AGENDA

DEVELOPMENT DETERMINATION PANEL MEETING

WEDNESDAY 26 OCTOBER 2022

northern beaches council

Figure 1. *Extent of eastern side boundary envelope non-compliance.*

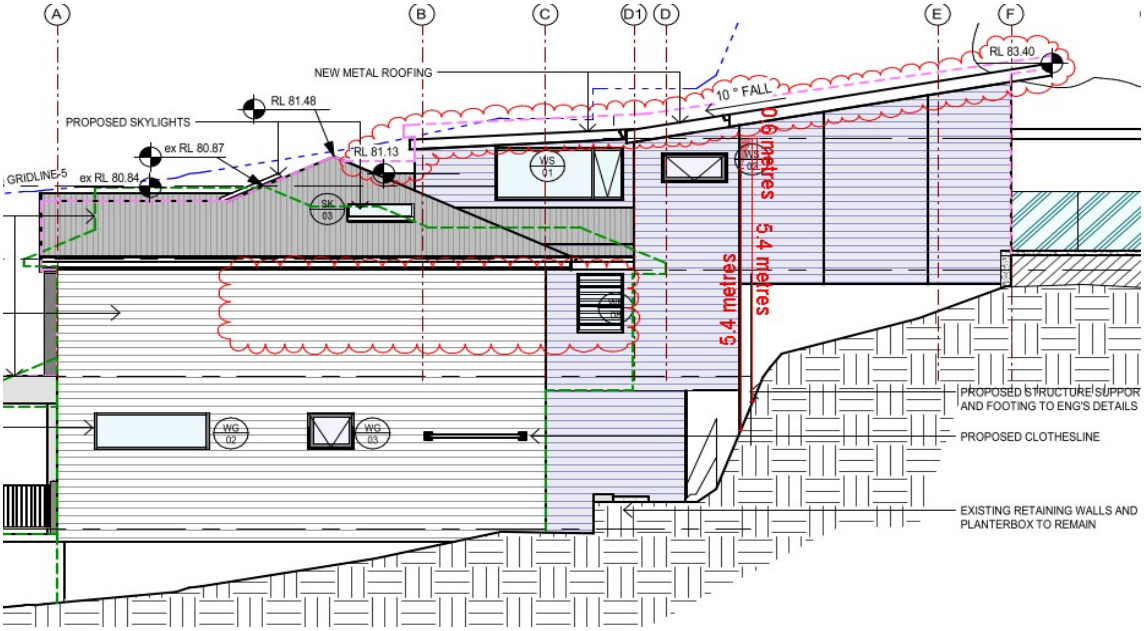
The proposal has one encroachment on the eastern elevation up to 0.6 metres for a length of 0.2 metres. This represents a variation of 15%.

Figure 2. *Extent of western side boundary envelope non-compliance.*

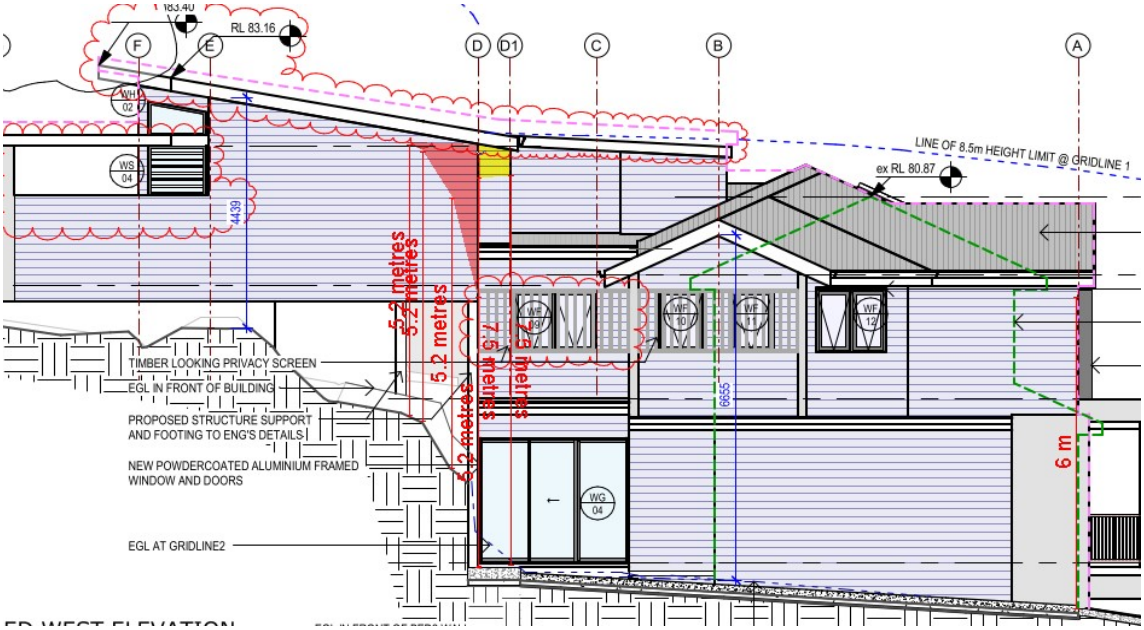
The proposal has two encroachments on the western elevation up to 2.9 metres for a combined length of 1.9 metres. This represents a variation of 72.5%.

Figure 1: Explanation of building height of proposed works and degree of non-compliance
Source: Y.in Architects, 2022

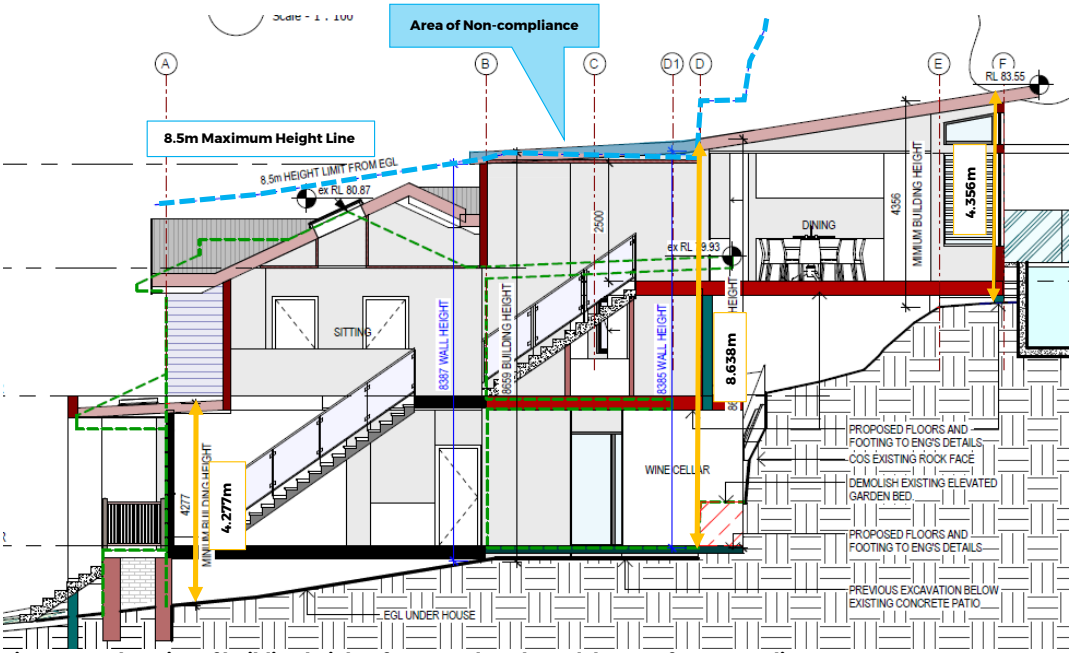
The maximum building height of the dwelling as existing is 7.7m (to the existing topmost roof ridge RL80.87). The proposed works will have a maximum height of 8.638m from the existing ground level to the roof ridge (RL82.35). Therefore, the proposal results in a minor non-compliance of 0.123m (refer to **Figure 1**).

This proposal results in variation of 1.4% to the development standard relating to the maximum building height required by Clause 4.3 of LEP 2011. In response to the proposed non-compliance, the following Variation Request is provided. We conclude that this Variation is well founded and is worthy of support by the Consent Authority.

Figure 2: 8.5m Maximum Building Height Plane
Source: Y.in Architects, 2022

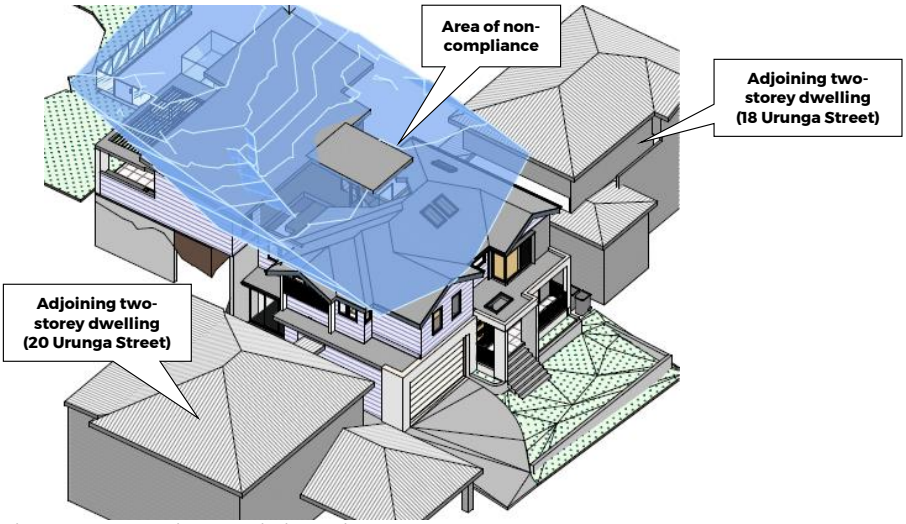
The part of the proposed development that breaches the development standard relates to a limited portion of the roof form within the mid-section of the dwelling above the proposed lift service, which will provide eased access for the occupants across all floor levels. The non-compliance is contributed to the sloping topography and terraced land on the site. In any case, the proposed dwelling will continue to have a fully compliant building height at the front elevation and present as two storeys within the streetscape, which is consistent with the adjoining dwellings (refer to **Figure 2**).

In addition to having a compliant building height at the front elevation, all new works are also fully compliant with the boundary setback controls outlined with the Warringah DCP 2011. Therefore, the dwelling on site will remain compatible with the height, bulk and scale of the surrounding development and will have a positive contribution to the desired character of the locality.

Figure 1 - South Elevation showing Envelope Breach

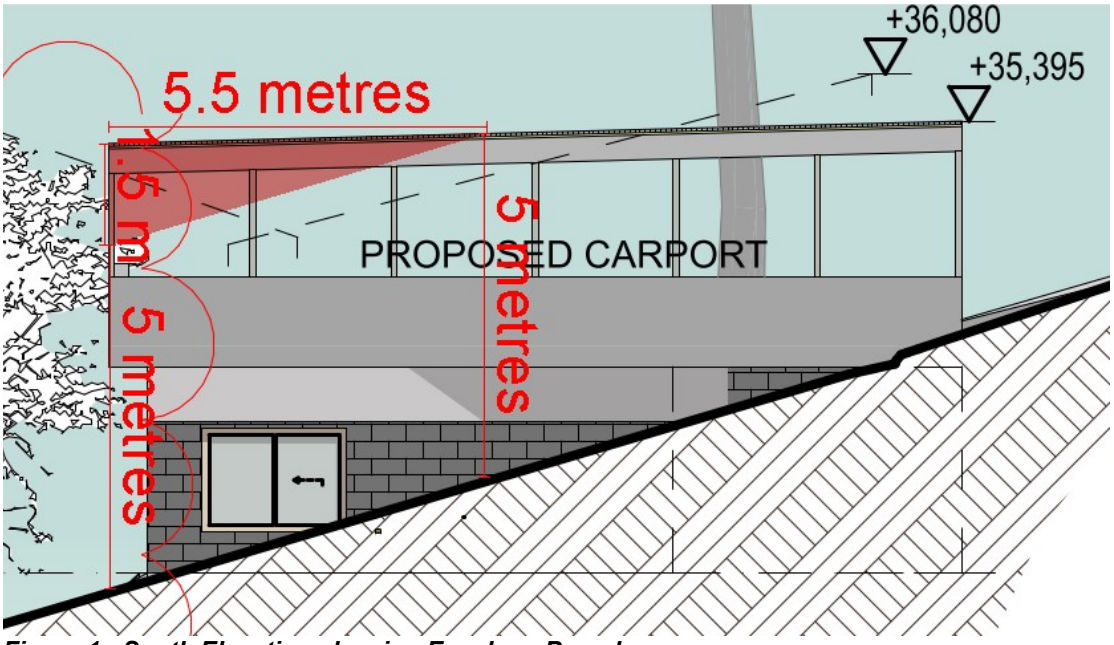
The proposed development breaches the envelope on the southern elevation between nil and 1.5 metres for a length of 5.5 metres.

Figure 1 (above): 8.0m height blanket from survey interpolated over CAD model of dwelling (encroaching element shown in white).

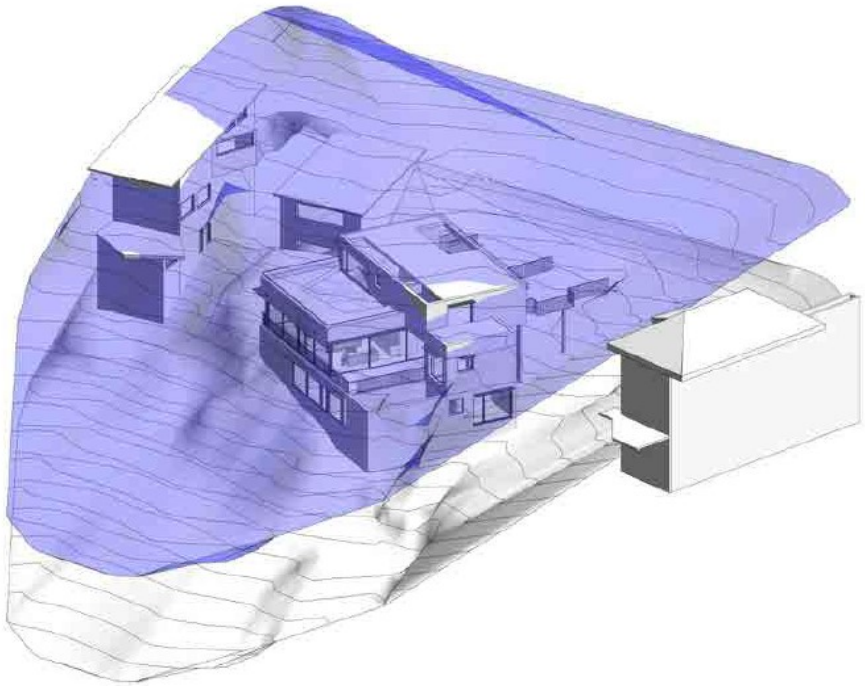
The northeastern corner of the proposed dwelling encroaches beyond the prescribed 8.0m building height plane, as depicted in the below diagram provided by the project architect:
